Project Number: SP2024-00004

Project Name: MVFR Meadow Sweet - Station #15. FLATIRON MEADOWS

SPECIAL REVIEW USE SITE PLAN SP2024-00004; SRU2024-00001

Re: Special Use Review Comment Responses

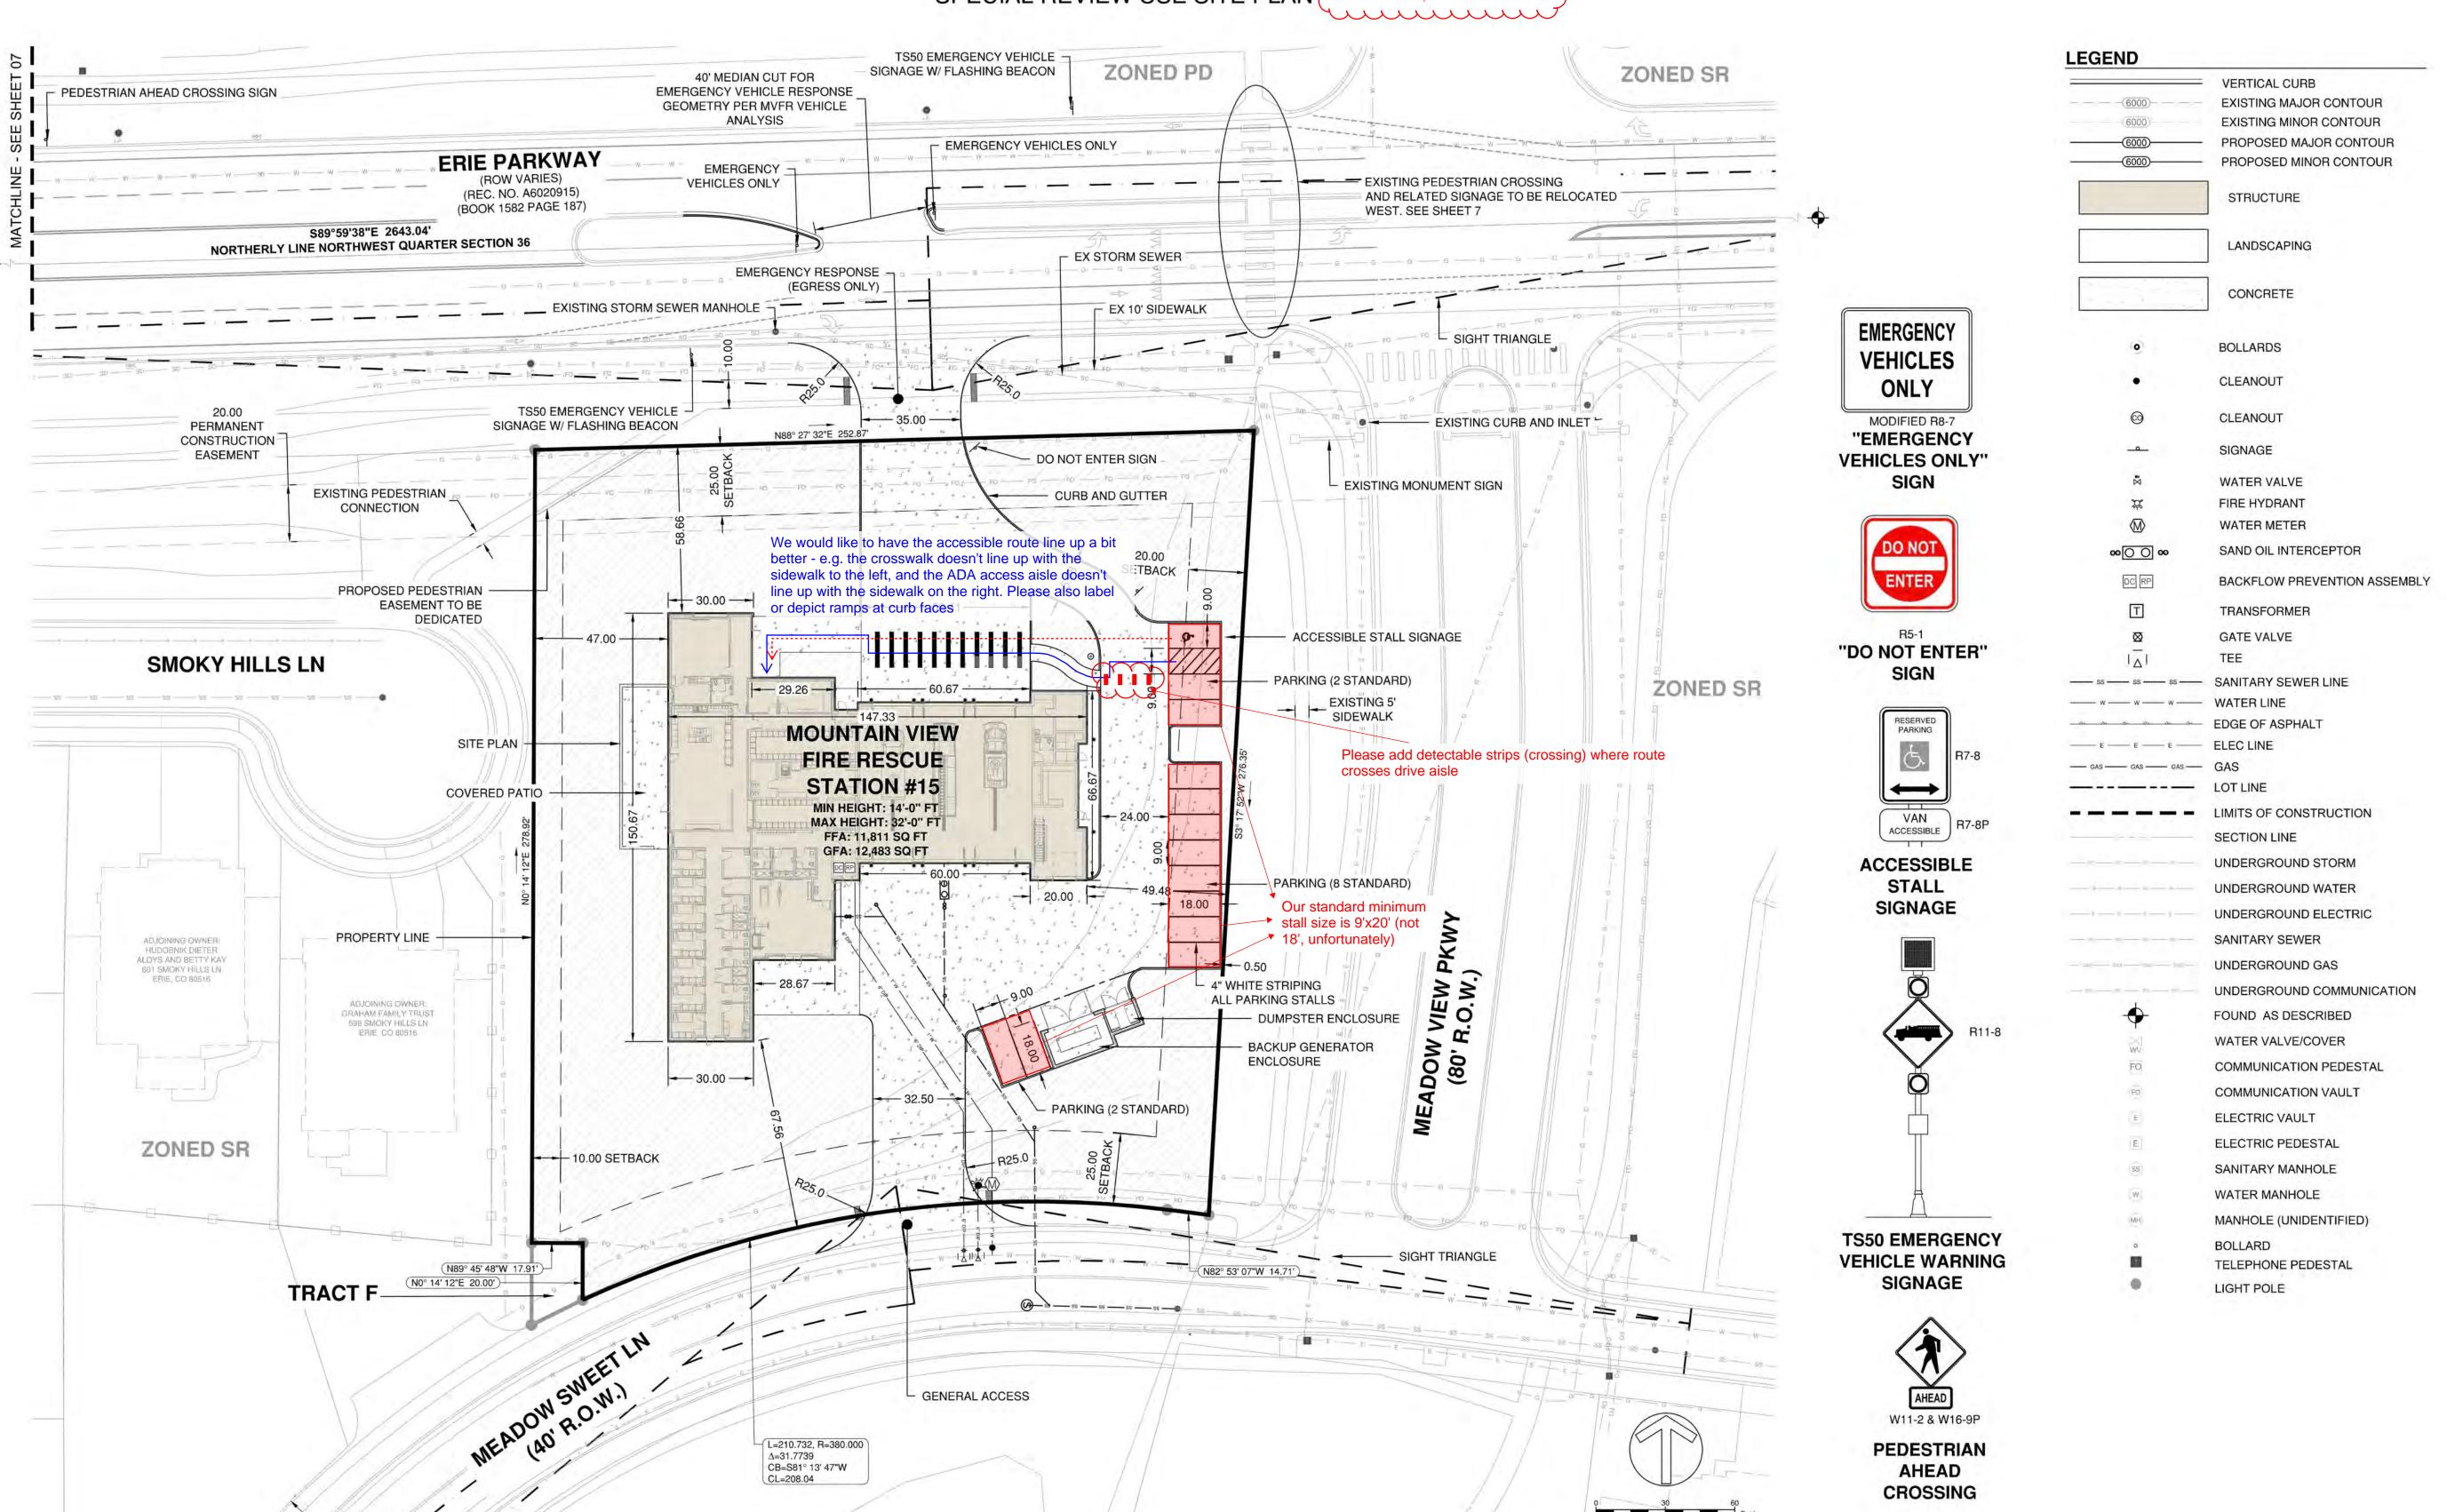
The Town has adopted the 2021 IEC and 2023 NEC; So there is a requirement for EV and EV ready parking spaces. The Building Department will be able to tell us what this requirement is.

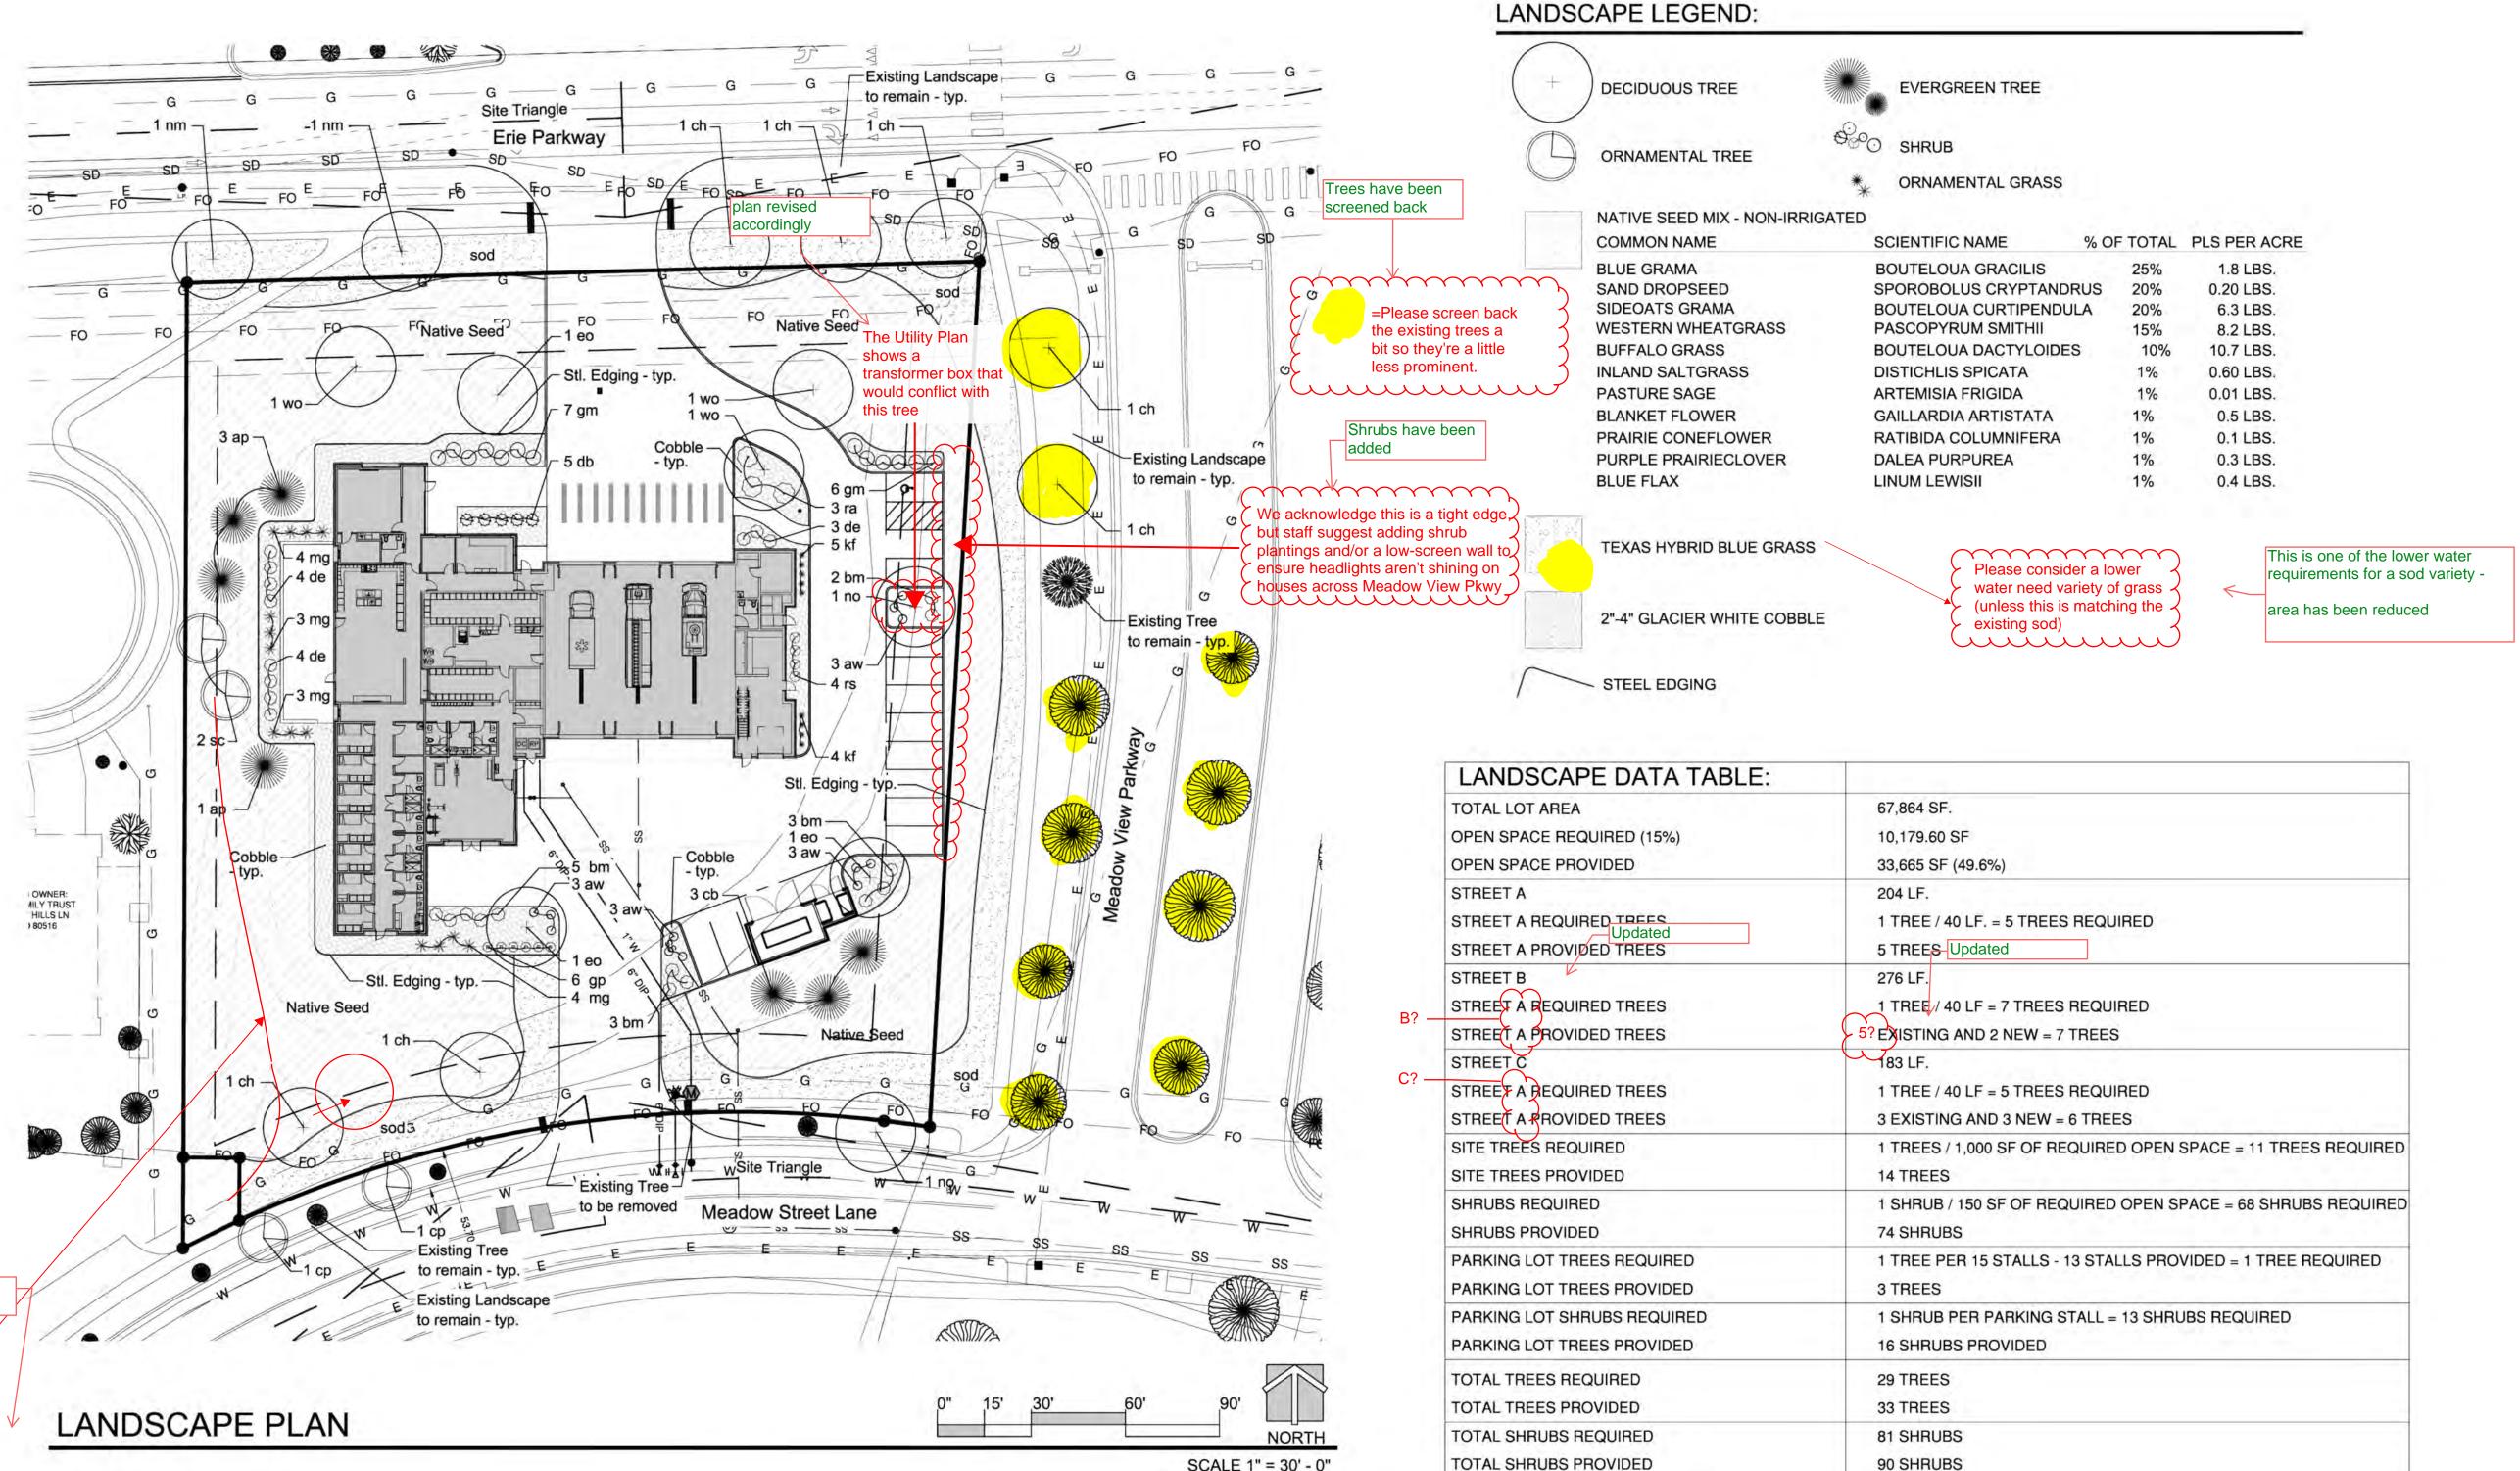
Titleblcok has been

Please label with the new parcel nomenclature from the plat -FLATIRON MEADOWS FILING NO.14 MINOR SUBDIVISION

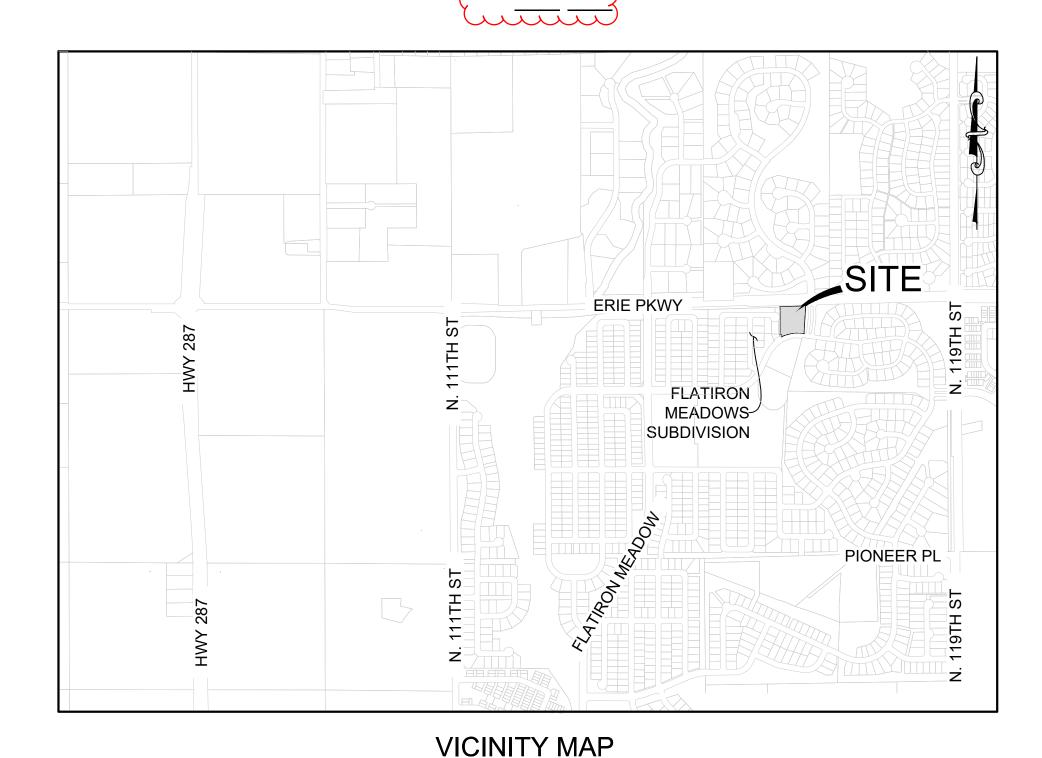
I don't think we need this block - typically this is for dedications to a private entity (a Metro district or HOA). A dedication/acceptance for the town

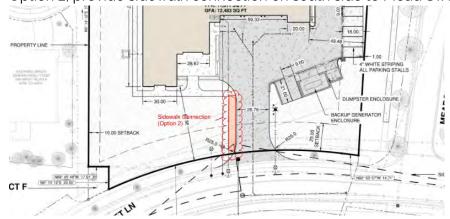
- Given the involvement of public improvements in the public ROW associated with this project, Engineering believes we will need a Development Agreement. I've attached a template for this development agreement and highlighted sections we will need from the applicant.
- Please add at least one sidewalk to provide pedestrian access into the site. One or both of the following options could be considered.

1. Option 1, provide sidewalk connection from Erie Parkway to main entrance of building.

2. Option 2, provide sidewalk connection on south side to Mead Sweet Lane.
